## ADDENDUM #2

**Date:** November 27, 2018  
**Project No.** 17205  
**Project Name:** Access Drive and Trailhead (Pigeon Forge, Tennessee)

**2 SITE SIGNAGE**  
SCALE: NTS

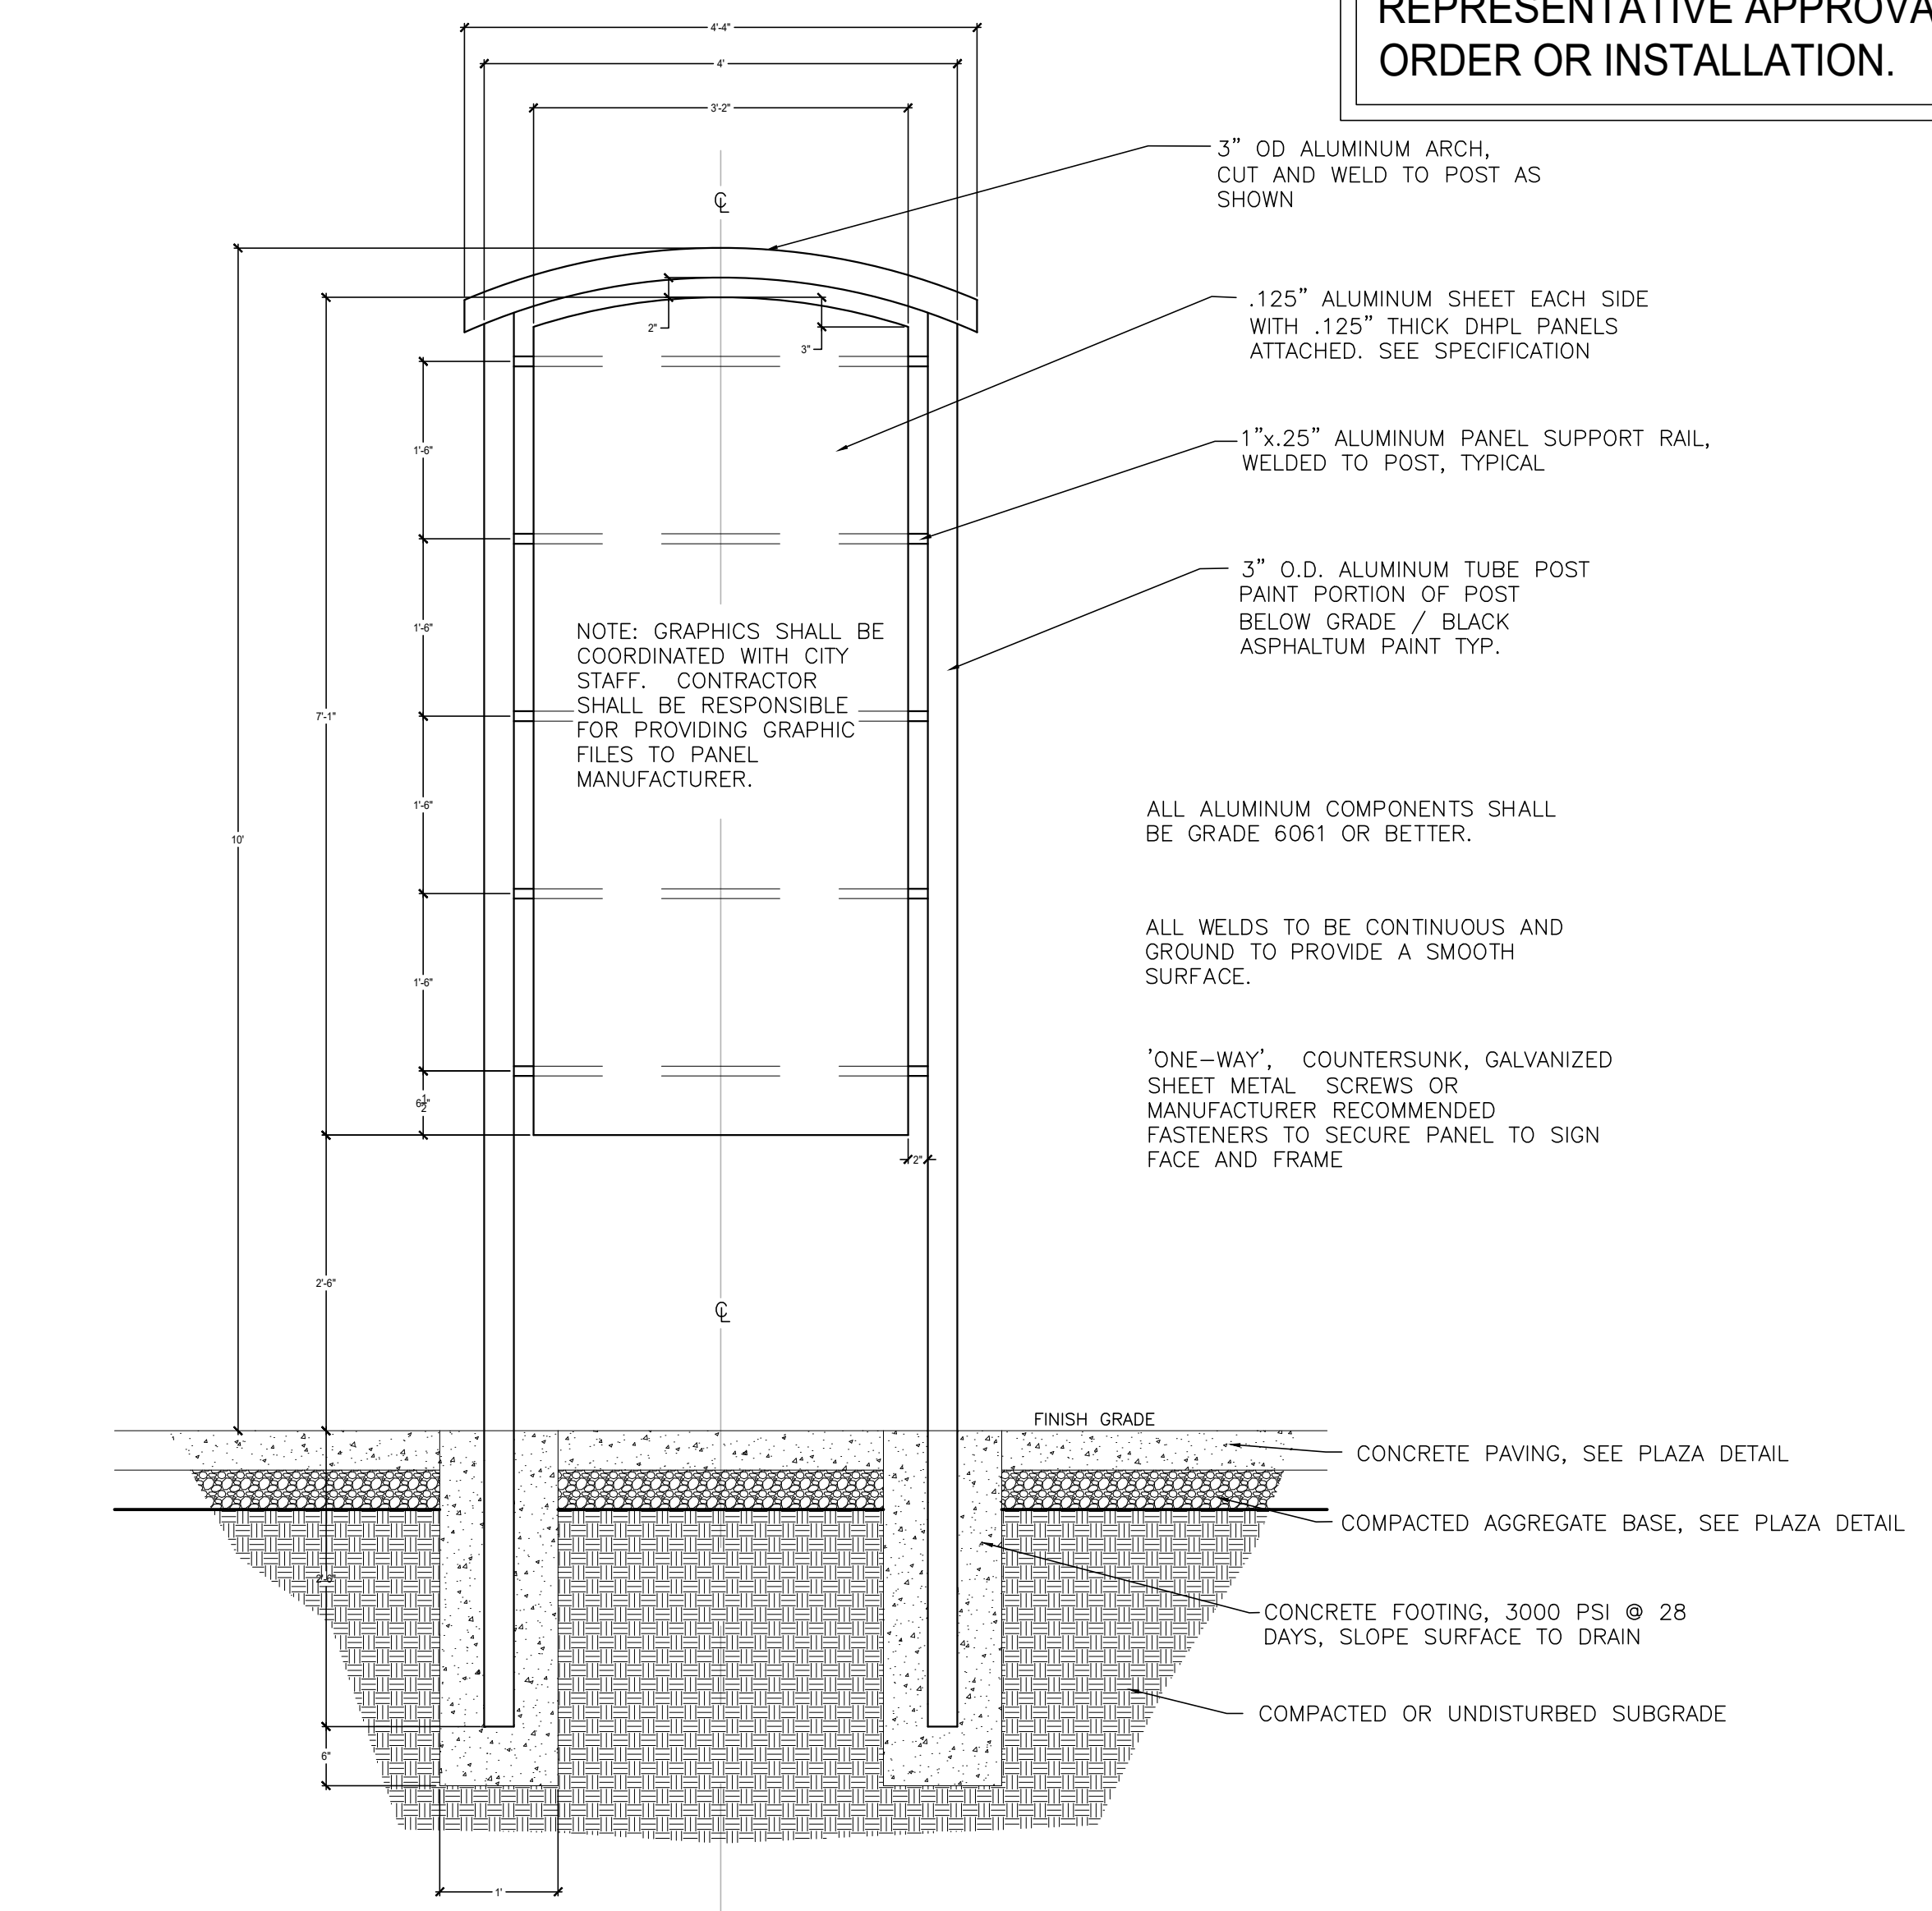
1. Sheets C2.91 and C4.04 were not included intentionally in the re-bid set due to the reduced area and scope of the project.
2. Detail 2, Sheet C4.01 has been updated to provide additional information on the materials used for the site signage. (See Attachment).
3. **Bid Date Extension:** Due to late questions submitted, the bid opening date has been extended to 2pm December 13, 2018.

**SIGN PROVIDED AS A BASIS OF DESIGN. CONTRACTOR SHALL PROVIDE SHOP DRAWINGS FOR OWNER AND REPRESENTATIVE APPROVAL PRIOR TO ORDER OR INSTALLATION.**
